TENNESSEE VALLEY AUTHORITY

October 9, 1981

WATTS BAR NUCLEAR PLANT UNITS 1 AND 2  
RESPONSES TO NRC POWER SYSTEMS (MECHANICAL) BRANCH REVIEW CONCERNS

WATTS BAR NUCLEAR PLANT UNITS 1 AND 2  
RESPONSES TO NRC POWER SYSTEMS (ELECTRICAL) BRANCH CONCERNSSection 8.2.2.1 - Availability of Offsite Power Circuits

WATTS BAR NUCLEAR PLANT  
ATTACHMENT TO REVISED  
RESPONSE TO QUESTIONS  
40.105 AND 40.106

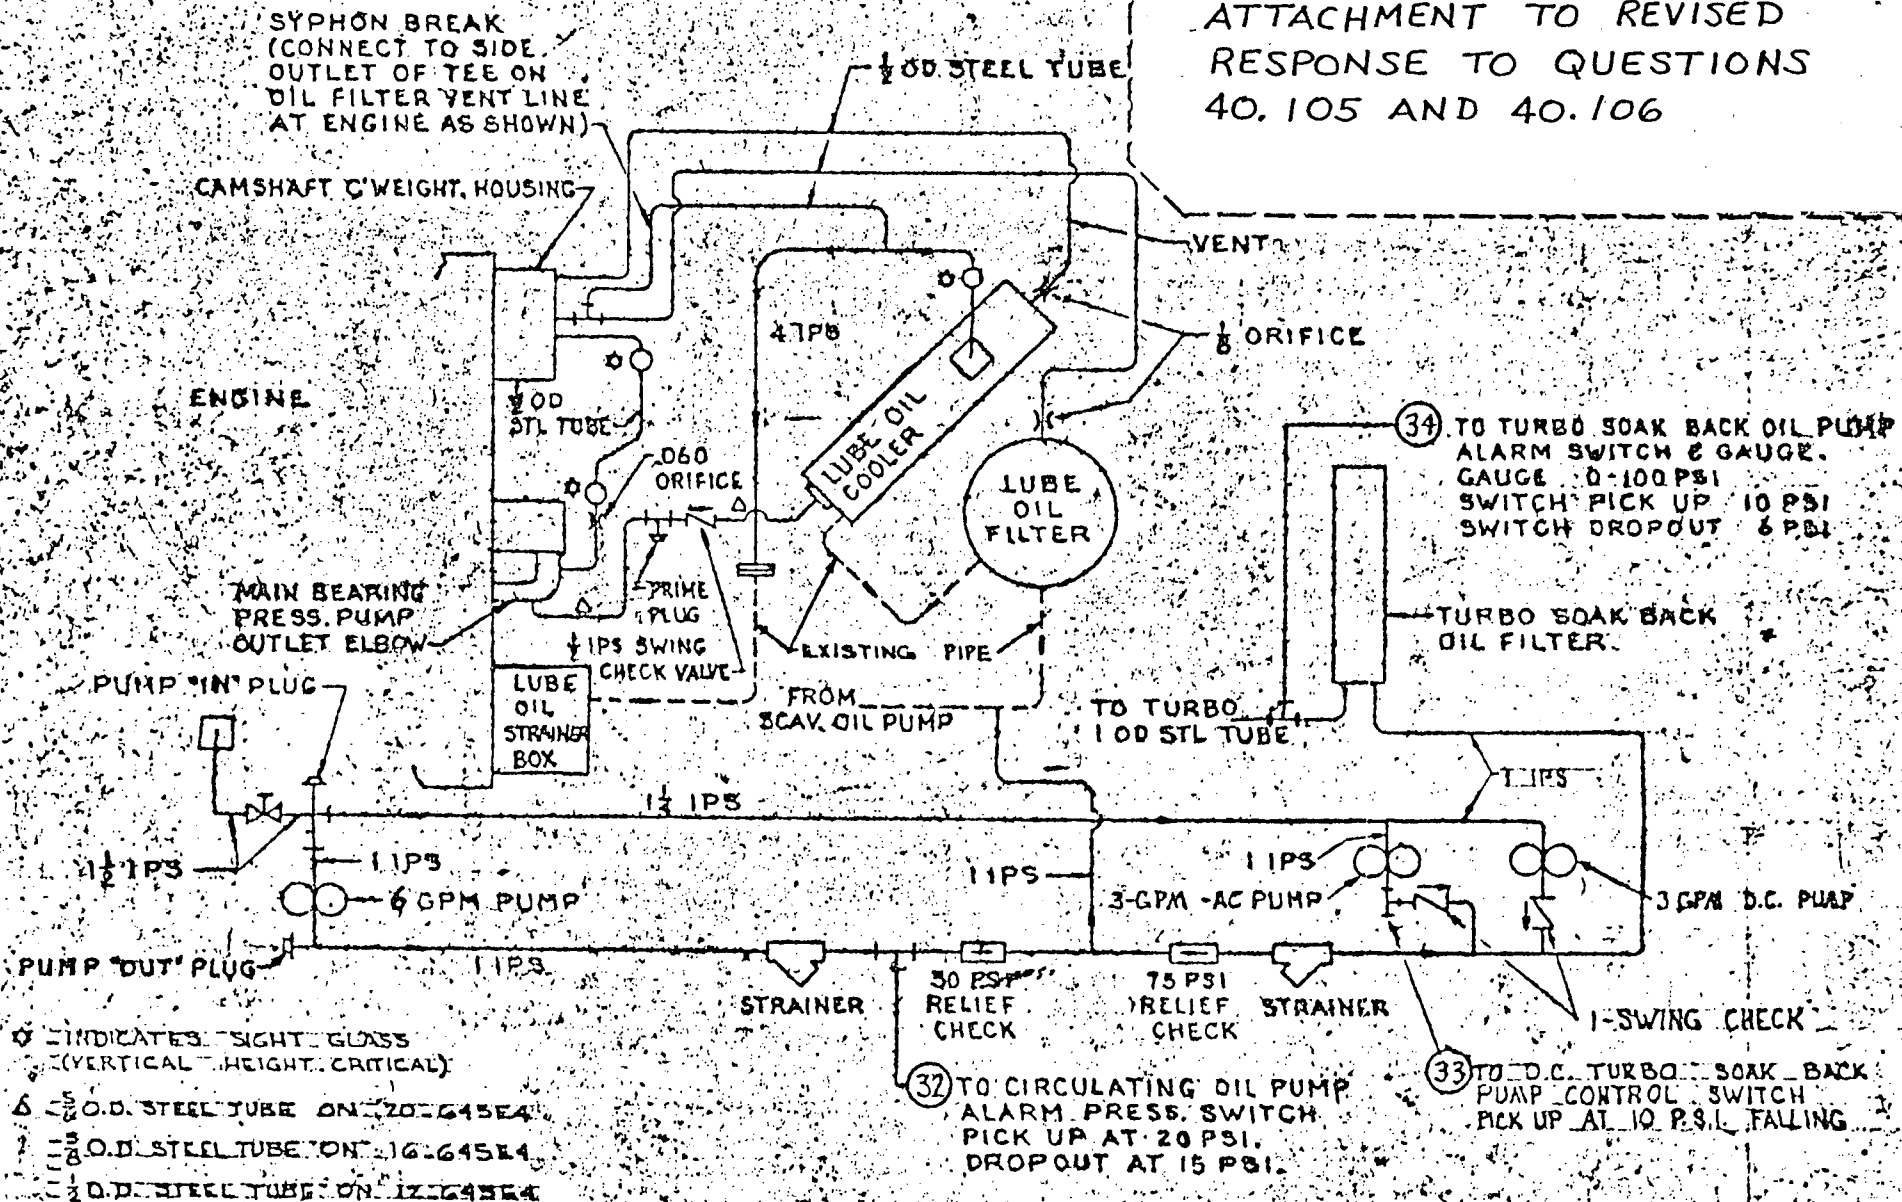
Questions 40.105 and 40.106

The diesel engine manufacturer (EMD/GM) has proposed a modification to the lubricating oil system shown in the attached diagram. Included in this modification are a dc motor-driven pump, an additional ac motor-driven pump, and piping modifications. The dc motor-driven pump supplies oil to the turbocharger if the ac motor-driven pump cannot and provides a method of removing heat from the turbocharger bearings if the engine is shut down without the ac pump operable. The additional ac motor-driven pump ensures proper lubrication of the turbocharger during the start sequence. The piping modifications preclude the draining down of the lubricating oil system and provides warm oil directly to the engine crankshaft bearings during standby, thus providing protection from 'dry' starts and improves standby temperature maintenance. TVA intends to complete this modification prior to fuel loading at WBNP-1.

Figure 8.3-55

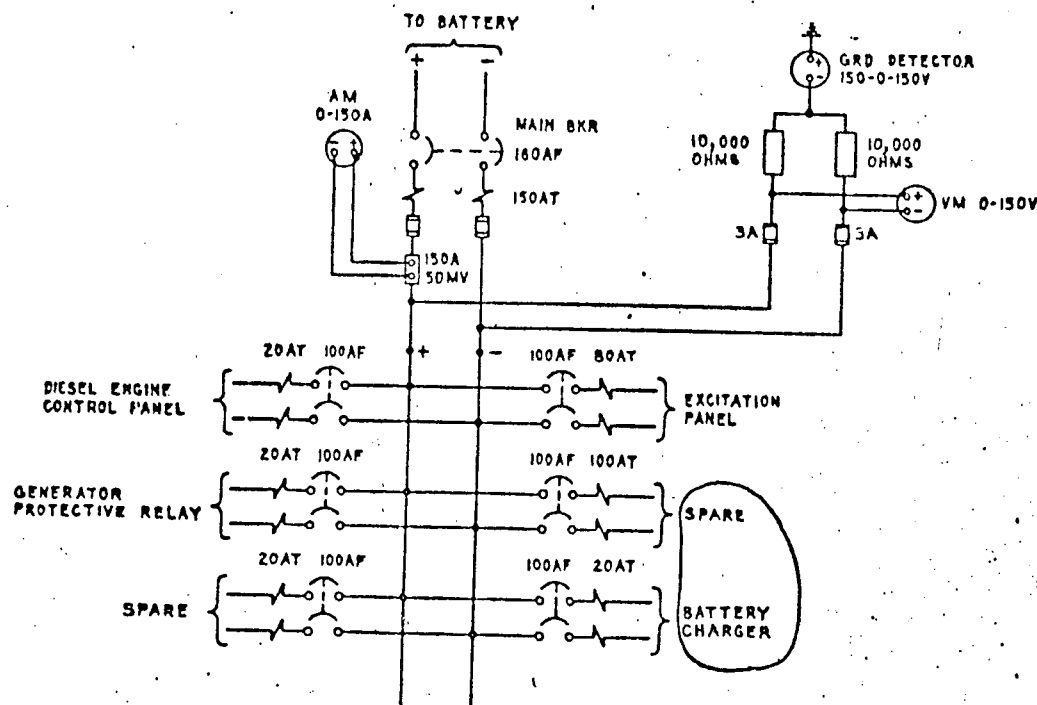
The diesel-generator 125-volt dc control and field flash circuits are supplied power from their respective dc distribution panels located in the diesel building on E1. 742 (see figure 8.3-1). A typical panel

and its associated loads is shown on figure 8.3-55. Each circuit (including the battery charger input to the panel) is protected by a thermal-magnetic circuit breaker. The battery input circuit to the panel is protected by a thermal-magnetic circuit breaker and a coordinated fuse. Local metering on the distribution panel and battery charger includes battery and charger current, battery and charger voltage, and battery system ground detection. Low battery charger output voltage and loss of 480-volt ac supply to the charger is alarmed in the main control room.

SUBJECT PENETRATION CIRCUIT PROJECT WATTS BAR NUCLEAR PLANT  
BREAKER RELIABILITY

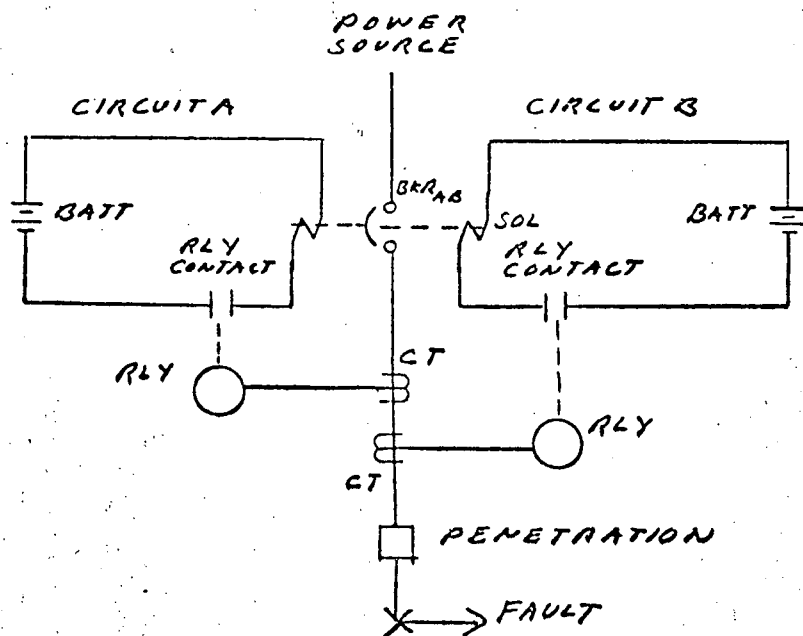
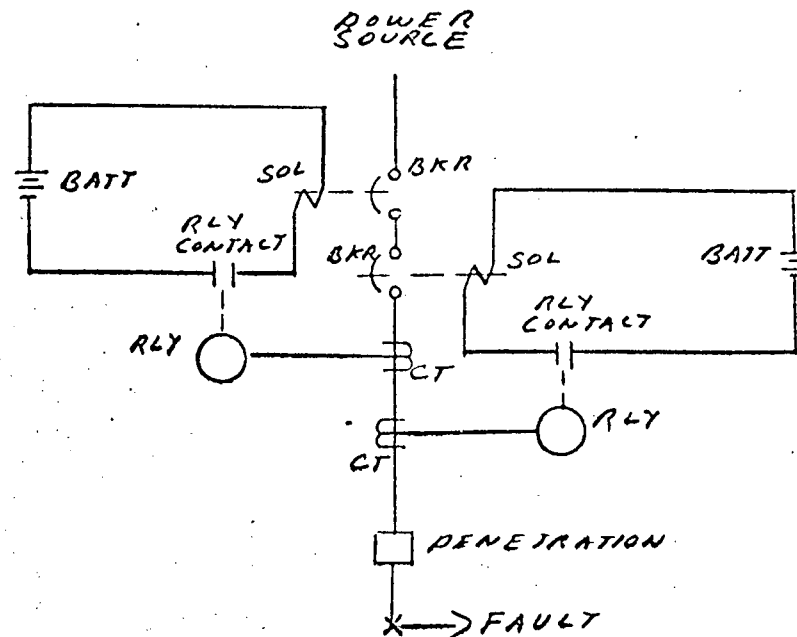
TO EVALUATE THE RELATIVE RELIABILITIES  
 OF THE CIRCUITS GIVEN ON SHEET 2  
 TO INTERRUPT A FAULT

CIRCUIT 1 IS A MINIMUM OF 98.19% AS RELIABLE AS CIRCUIT 2
